Review of US EPA's "Draft Investigation of Ground Water Contamination near Pavillion, Wyoming"

Halliburton Energy Services, Inc.
P.O. Box 42806
Houston, TX 77242-2806

Gradient
20 University Road
Cambridge, MA 02138

June 25, 2012

Figure 4.6 Methane Concentration in Domestic Wells *versus* Well Depth

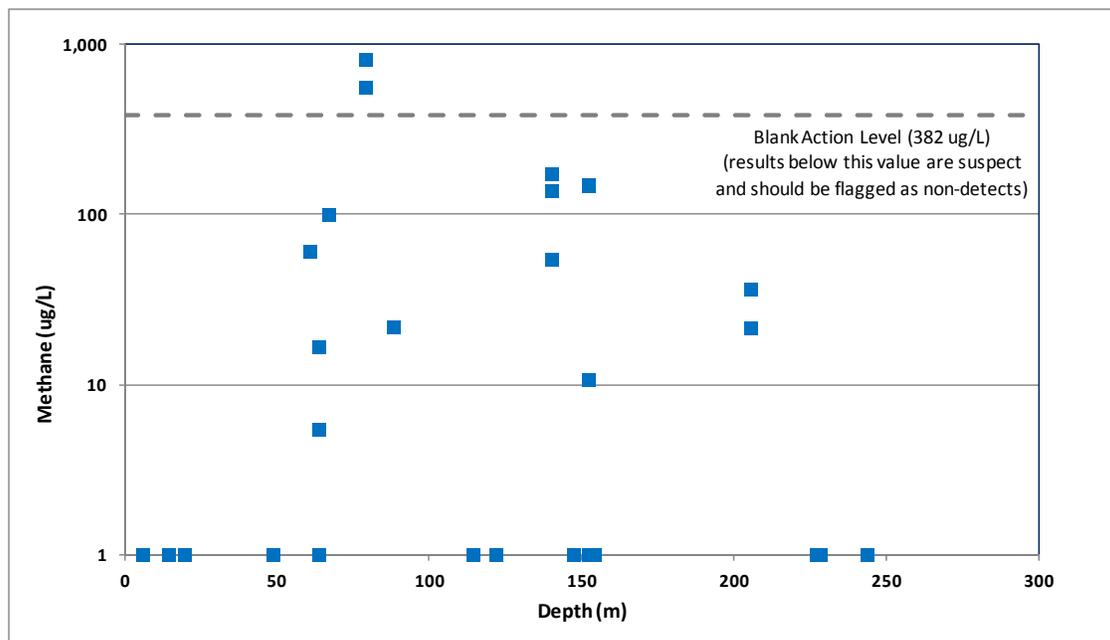
In addition, if methane were being released as a result of HF activities, as asserted by US EPA, one could also expect to see increasing methane concentrations with depth, where wells are in closer proximity to the gas production zones. As shown in Figure 4.6, there is no correlation between methane concentration and depth. In fact, if there is any pattern in the methane concentrations in the domestic wells at all, there is perhaps a slight tendency for higher methane concentrations in shallower wells than deeper wells. This pattern is inconsistent with the hypothesis that HF activities (*i.e.*, "deep source terms") are contributing to the methane concentrations in domestic wells.

Figure 4.7 Ratio of Methane to Ethane Plus Propane [$C_1/(C_2+C_3)$] versus $\delta C^{13} CH_4$ for Domestic Wells and Deep Monitoring Wells

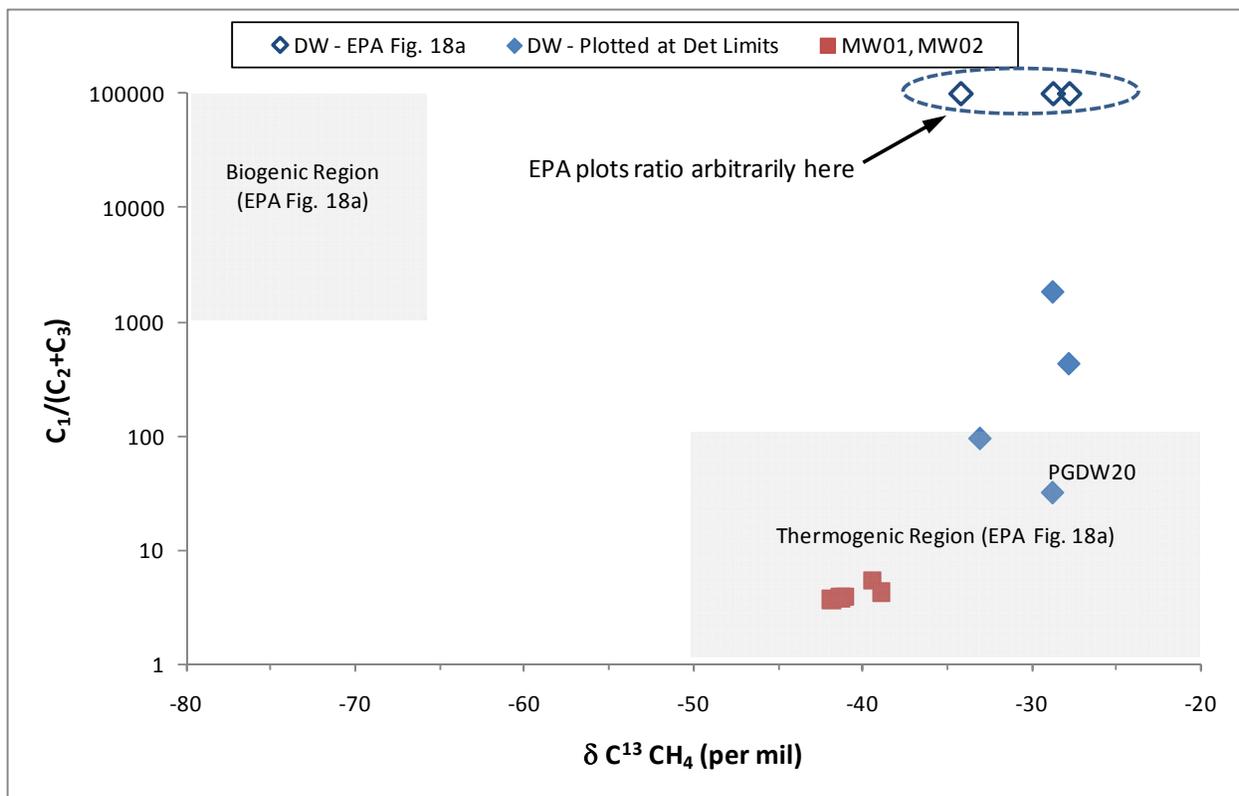
- Contrary to the claim in the Study, the interpretation is based on the sample results from only *three* domestic wells (PGDW20, PGDW30, and PGDW32), not four as the Study asserts; US EPA double counts two rounds of sampling from PGDW30.
- Of these wells, PGDW32 had no detectable methane in the Phase IV sampling, and only low levels in previous phases (21.4 $\mu\text{g/L}$ in Phase I and 36.3 $\mu\text{g/L}$ in Phase II). This draws into question whether methane is reliably present in this well, especially given the consistent detection of methane in blank samples. As discussed previously in Section 3.4 and in more detail below (in

- Neither PGDW30 nor PGDW32 had detectable ethane (C_2) or propane (C_3). Therefore, the ratio of $C_1/(C_2+C_3)$ is undefined. In Figure 18a of its report, US EPA arbitrarily plots this ratio as 100,000, giving the artificial and misleading appearance that it was significantly different than the ratios plotted for the "thermogenic" region.²⁹ Figure 4.7 below re-plots these data using the detection limits to calculate the $C_1/(C_2+C_3)$ ratio. This shows that the methane in PGDW30 and PGDW32 is primarily thermogenic in origin with small amounts of oxidation, as would be expected for groundwater overlying a gas-bearing region. These data do not support US EPA's implication of enhanced migration due to HF activities.

- PGDW20 (140.2 m bgs), which is plotted in Figure 18a in the "thermogenic" region, is 65.5 meters (215 feet) shallower than PGDW32 (205.7 m bgs). Thus, this well does not exhibit a pattern of "dispersion and degradation with upward migration" as hypothesized.
